Recall Campaign

December 2009
FL569A
NHTSA #09V-461

Copy of Letter to Owner Subject: KPPS Adjustable Brake Pedals

Work Instructions

Fig. 1, Adjustable Brake Pedal Assembly

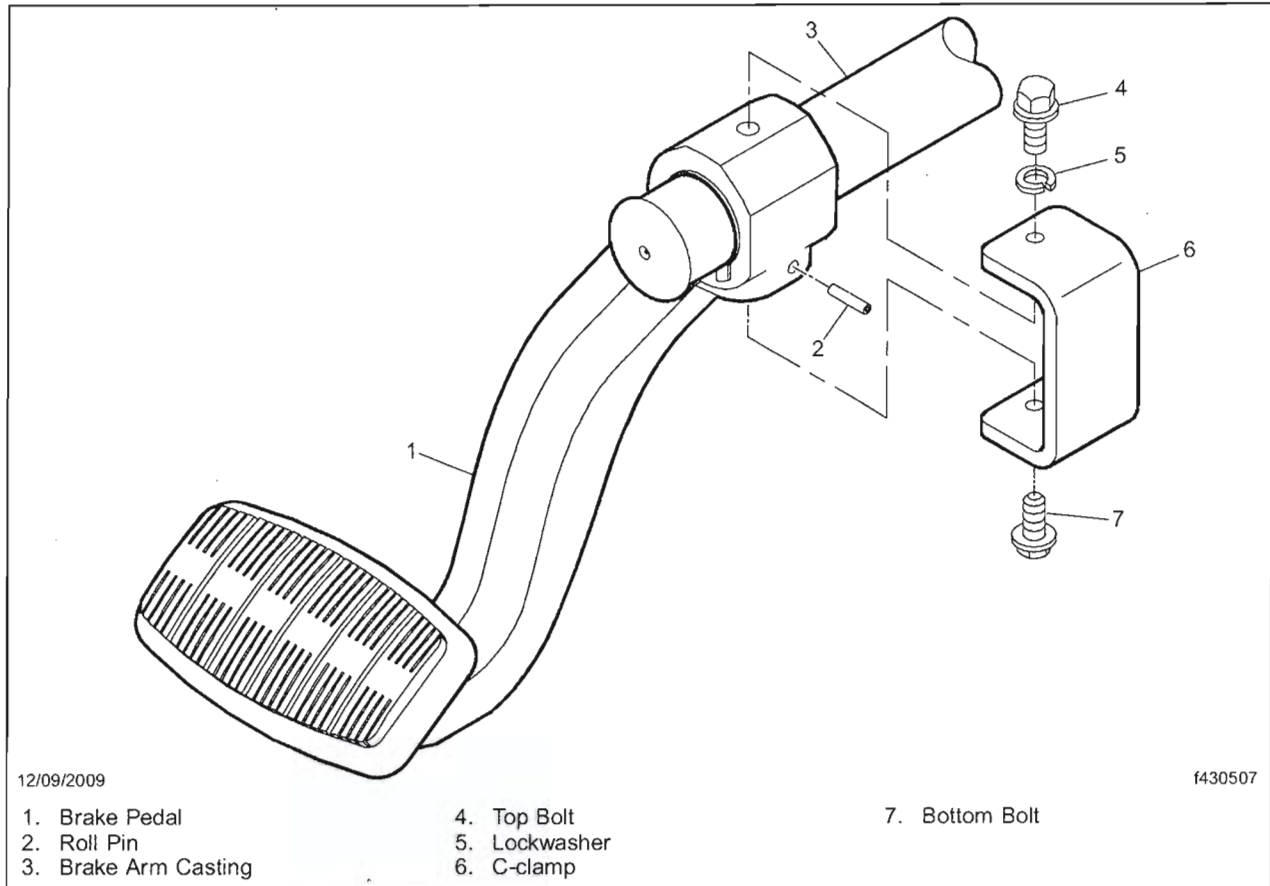
The adjustable brake pedal may loosen. The drive pin which secures the brake pedal arm to the balance of the assembly may become disengaged, this may cause a reduction in vehicle braking and/or cause the brake pedal to move out of position and interfere with throttle pedal function. A reduction in braking or interference with the throttle pedal could result in a vehicle crash.

A clamp assembly will be installed on the adjustable brake pedal arm, preventing it from loosening.

1. With the C-clamp in your hand, install the C-clamp assembly in the guide hole at the top of the brake arm casting. Make certain the C-clamp is against the casting and tighten the top bolt 40 ± 5 lbf-in (452 ± 5 N·cm). The bolt with the lockwasher should be installed at the top, as shown in **Fig. 1**, Items 4 and 5. Then tighten the bottom bolt 40 ± 5 lbf-in (452 ± 5 N·cm).
2. Remove the chocks from the tires.
3. Clean a spot on the base label (Form WAR259), write the recall number, FL569, on a blank completion sticker (Form WAR260), and attach it to the base label.
